NOTICE OF MEETING

TO: Planning Commission
FROM: Ben Prchal, City Planner
AGENDA ITEM: Variance Requests - 9447 Stillwater Blvd.
REVIEWED BY: Ken Roberts, Planning Director

PROPOSED VARIANCES

AGENDA ITEM: Approve Engineering Design and Construction Standards Manual –
APRIL 2019 Revisions

CERTIFICATE OF
SURVEY

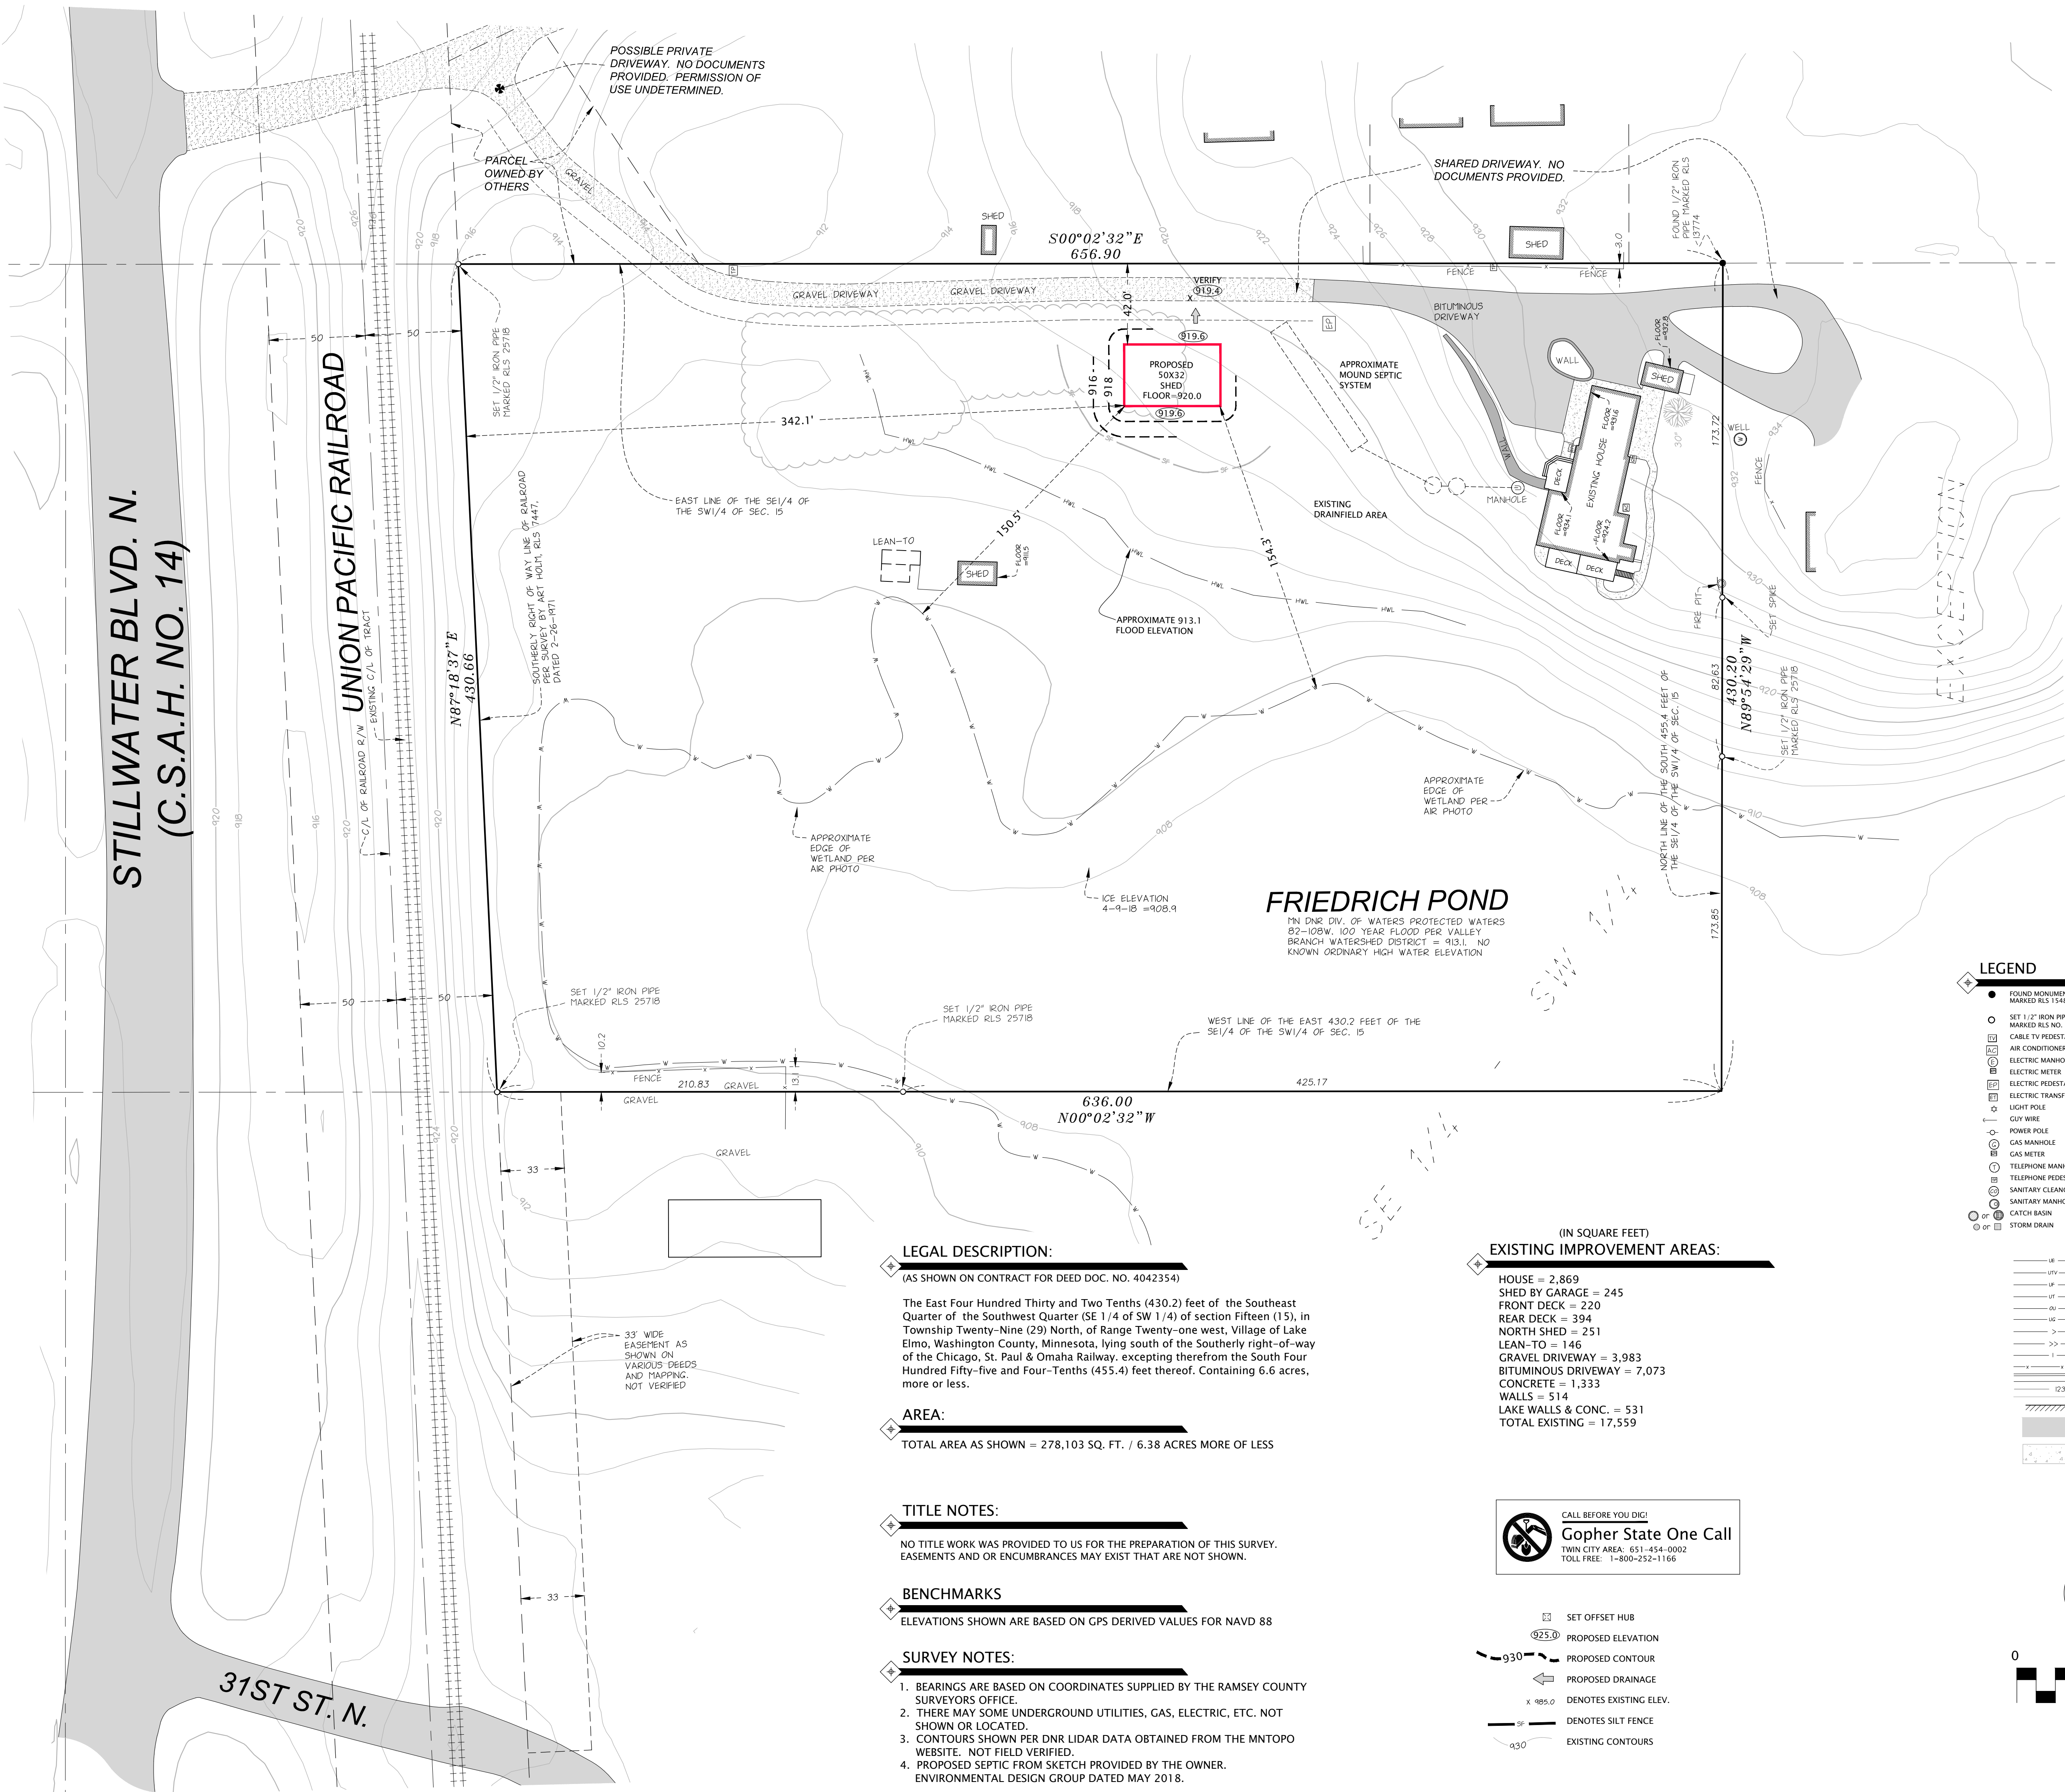
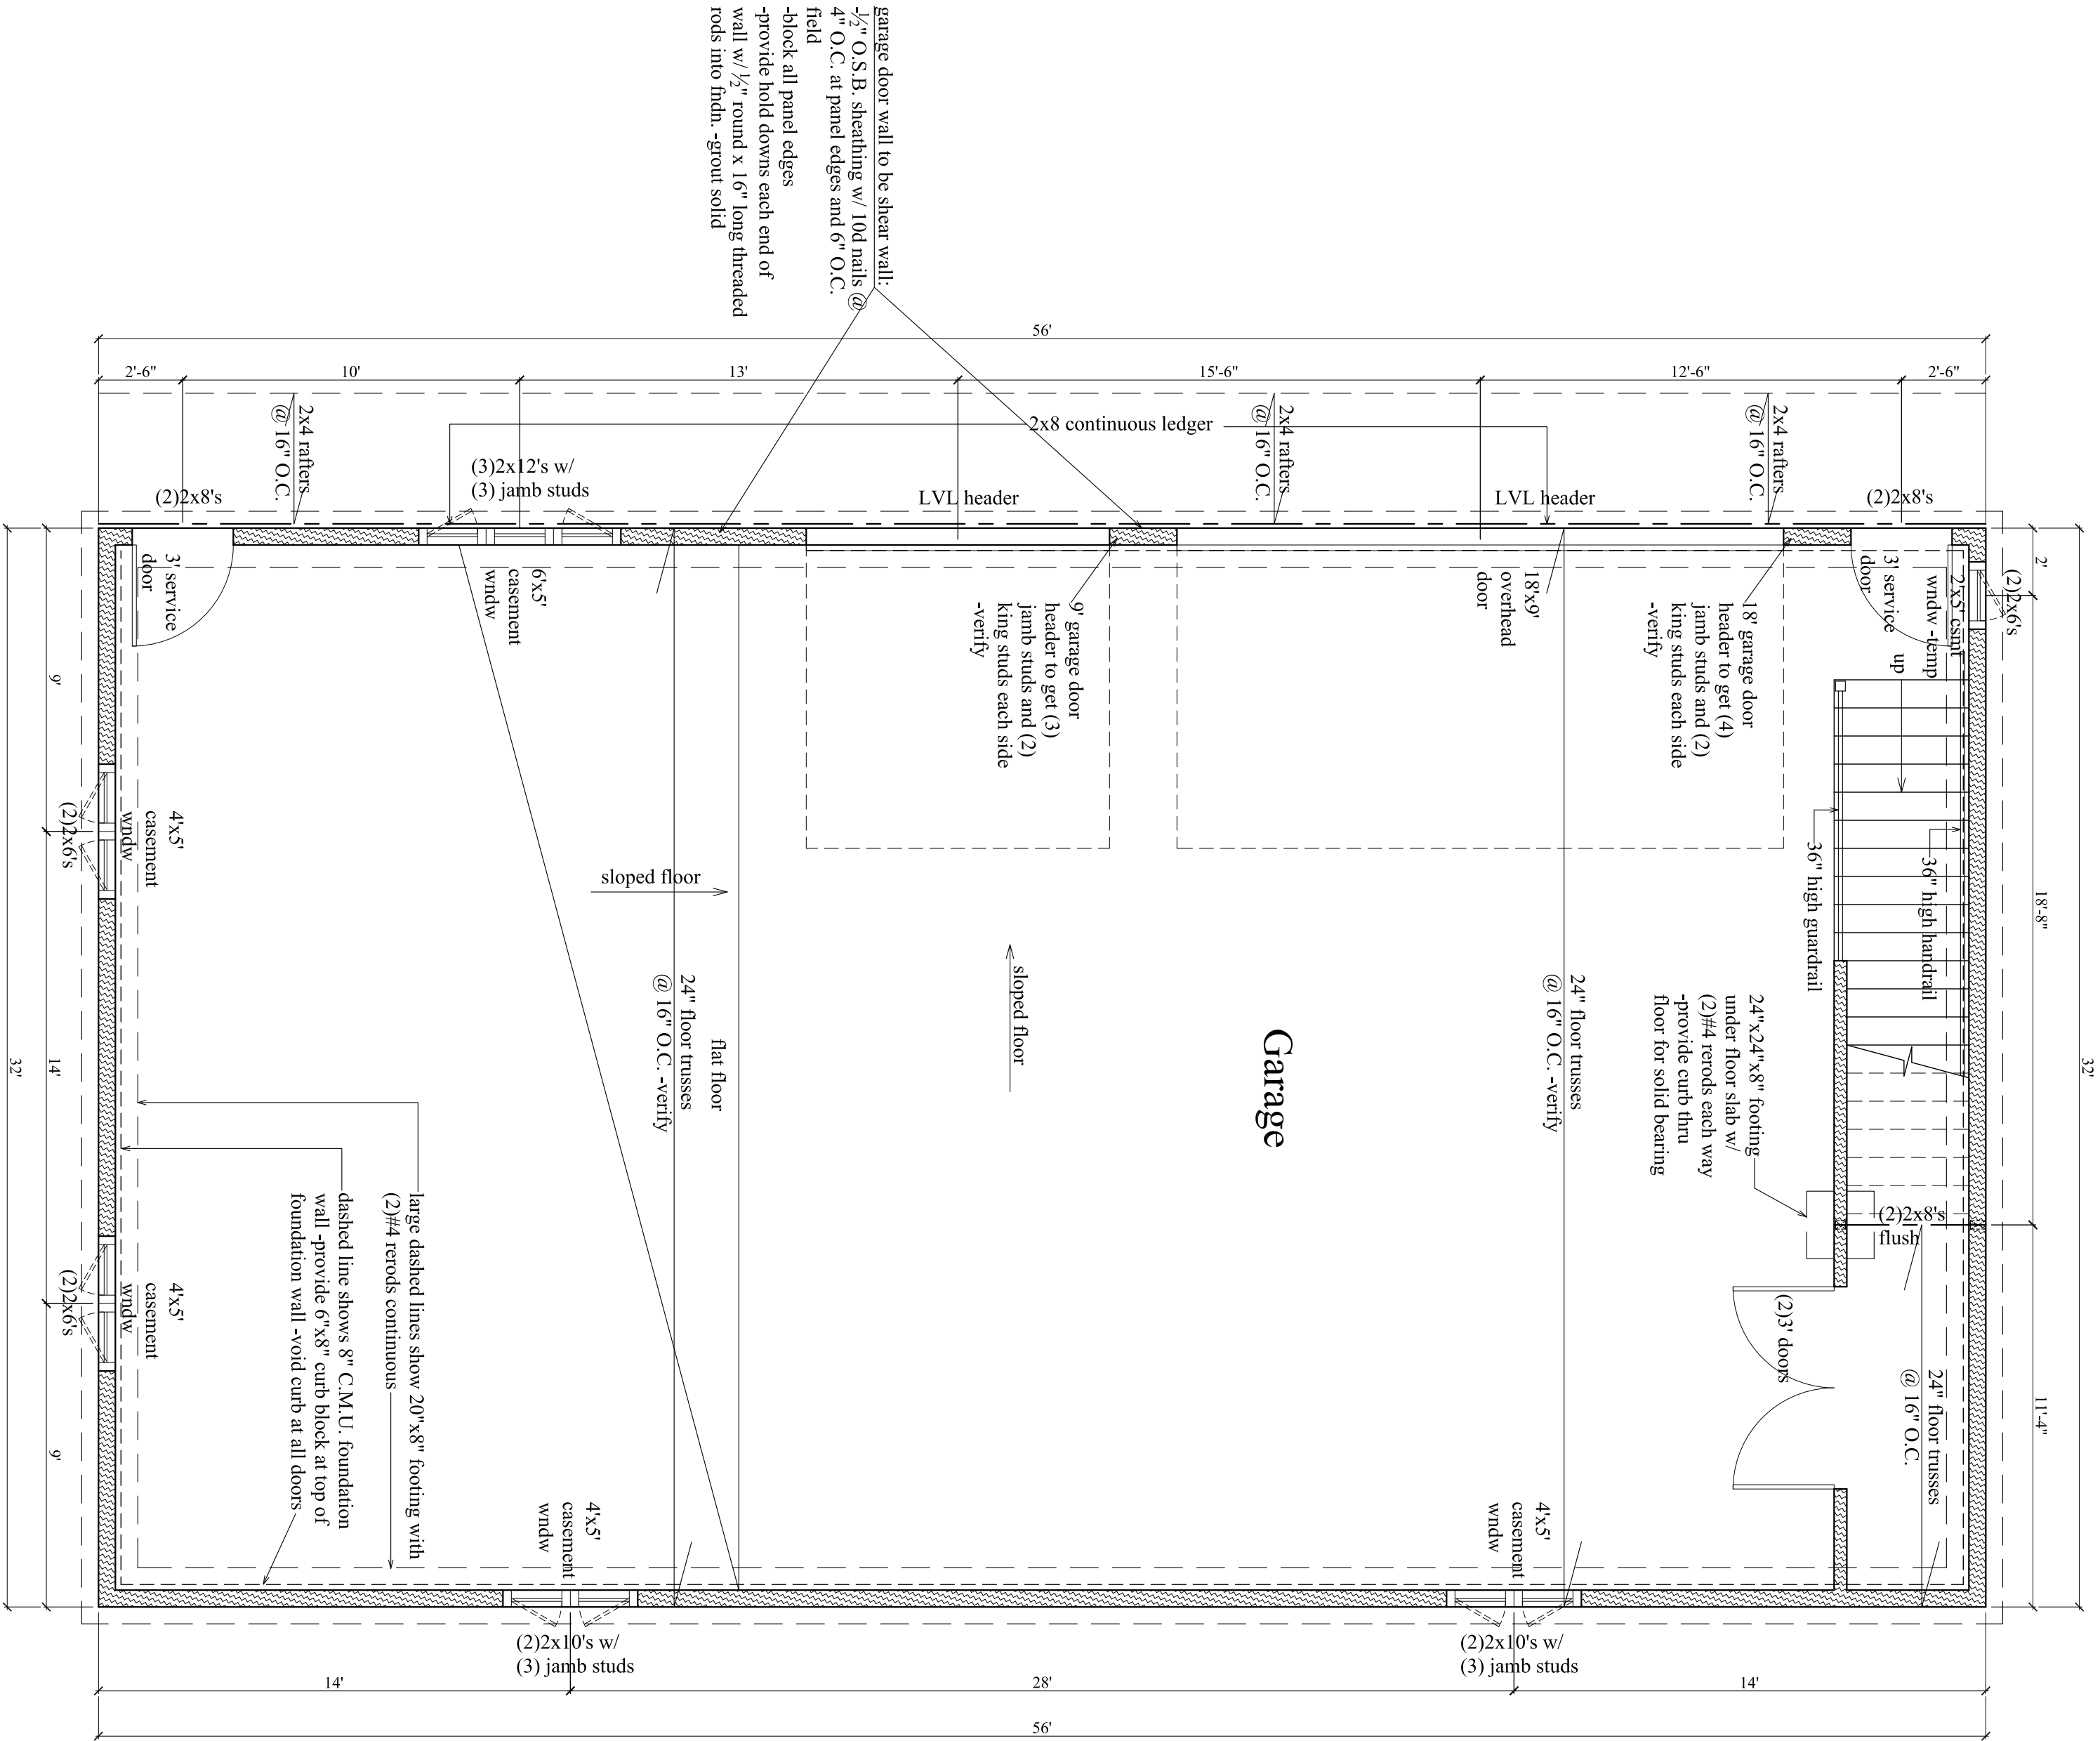
Variance Requests. The applicant is requesting to build an accessory building closer to the front lot line than the principle structure. The City Code addresses accessory building and currently proposed design would also exceed the maximum allowed height of 22 ft. Accessory structures are limited to 22 ft. or the principle structure, whichever is more restrictive. The needed variances are outlined in the tables and an in-depth explanation is provided below the tables.

Standard	Required	Proposed
Setback from the Front Property Line.	30 ft. Or The Principle Structure	342.1 ft. Closer to the Front lot line than the home.
Structure Height	22 ft.	25 ft.

The applicant is requesting the variance for the structure to be located closer to the front lot line because of the geographic features of the lot and location of the home leaves very limited space behind the home. Furthermore, the applicant is also requesting a variance from the structure height requirement. The applicant would like to build a two story shed and has met the requirement that the structure cannot be taller than the principle structure but the code places a second limiting factor, stating that accessory buildings also cannot be taller than 22 ft. The applicable sections of code will be outlined below.

As previously noted accessory buildings cannot be located closer to the front property line than the principle structure. Geographic constraints coupled with the location of the home would make construction in the side or rear yard difficult. There is also a shared driveway for the property addressed as 9495 Stillwater Blvd. This driveway is on the east side of the home, placing a structure on the east side of the lot would drastically impede the function of the driveway.

1. That the Applicant obtain all applicable permits including but not limited to a City building permit including a grading, erosion control, and storm water management plan approved by the City Engineer.
2. That the Applicant must reduce the height of the building to 22 ft. unless the property is reclassified to Agricultural. If reclassified, the applicant can increase the structures height to 25 ft.
3. If approved this variance approval is valid for 1 year and would expire on XXX. (date set after council approval)
4. One of the other smaller accessory buildings noted on the survey must be removed prior to the issuance of a building permit of the new accessory structure.
